Our Ref: 22032

28 March 2022

**RE: 45 MOBBS LANE, CARLINGFORD
ASSESSMENT OF DRIVEWAY ISSUES**

AS2890.1 (2004) Sight Distance Requirements

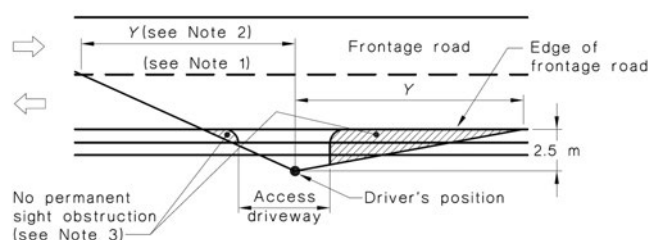
This is the sight distance required for a driveway according to the Australian Standard. As this is a driveway and not a road, the provision of this satisfies the sight distance requirements

Figure 3.2: Safe intersection sight distance (SISD)

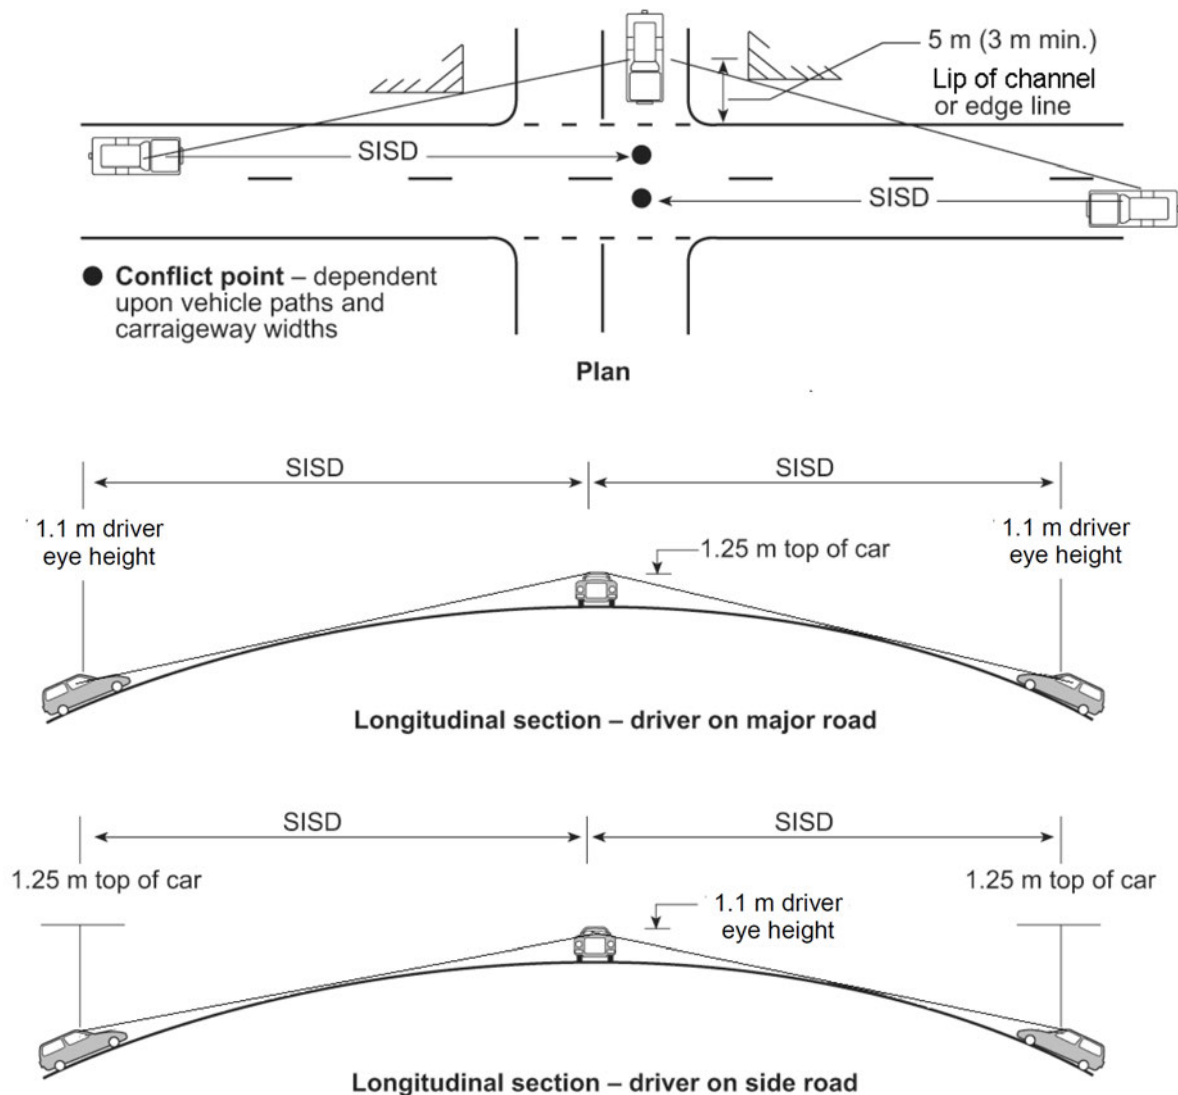
SISD is the minimum sight distance which should be provided on the major road at any intersection at a height of 1.25m. It is noteworthy that this requirement is for an intersection rather than a driveway although the Austroads document says that this requirement can be used as the basis of assessments at busy driveways.

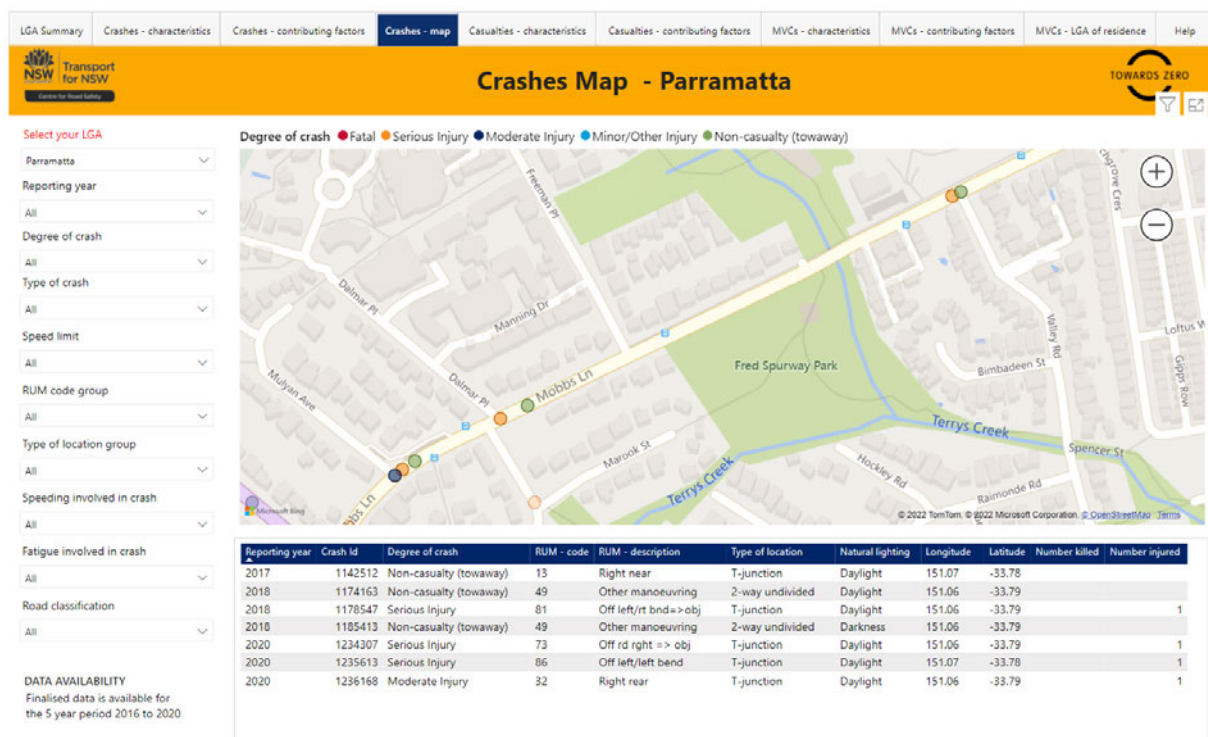
The analysis of these sight distances, contained at **Annexure B** confirms that the available AS2890.1 driveway sight distance and MGSD can be adequately provided but the SISD is marginally compromised by the profile of the road.

In summary, the sight distance for a driveway is met, as is the MGSD but the more onerous Safe Intersection Sight distance cannot be achieved but I would suggest that this driveway is not an intersection and so this standard need not be applied.

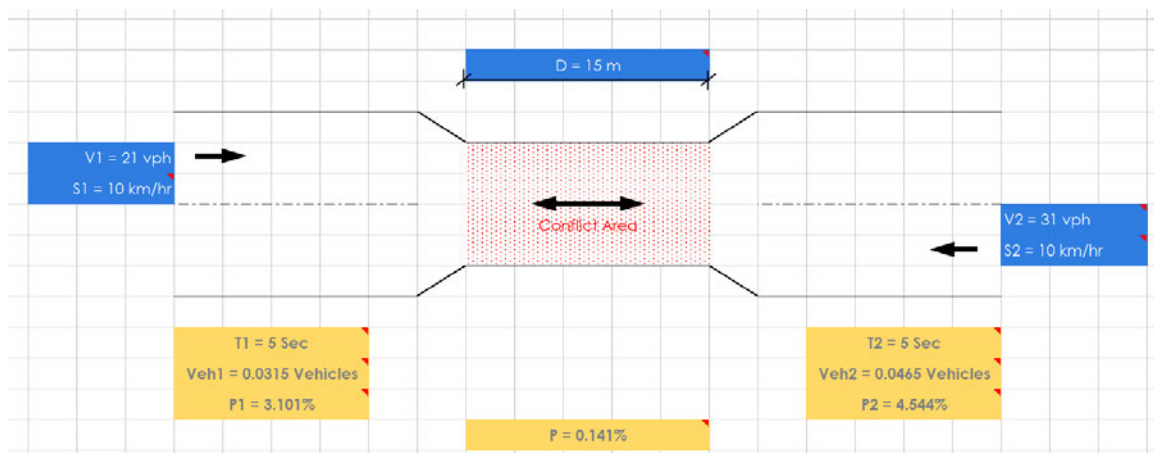
- the reliance on basement parking is unsatisfactory and the operators cannot guarantee use of the basement area by parents; the likelihood of queuing of vehicles entering the basement area.

Most Councils DCP's insist on all parking being provided on site so I find it unusual that the panel would suggest that reliance on basement parking is unsatisfactory.

Indeed, Council's DCP says that adequate off-street parking needs to be provided to serve the needs of the development.

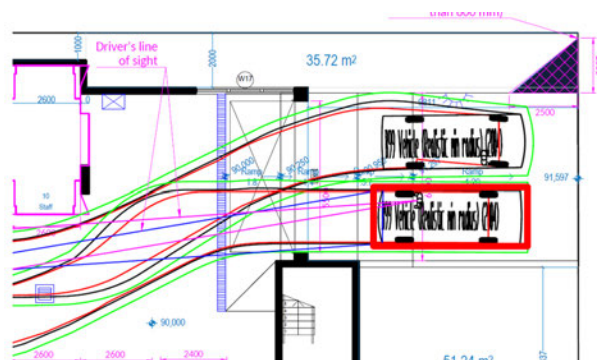
- Assuming an inflow of 31 vehicles per hour and an exit flow of 21 per hour (as taken from the traffic report), a speed of 10km/h and a conservative conflict distance of 15m, the chances of any vehicles meeting are about 0.14%

Moreover, there is room for a car to wait within the property boundary if there is a car coming in the opposite direction. So even if there is a conflict, there will not be an operational problem.
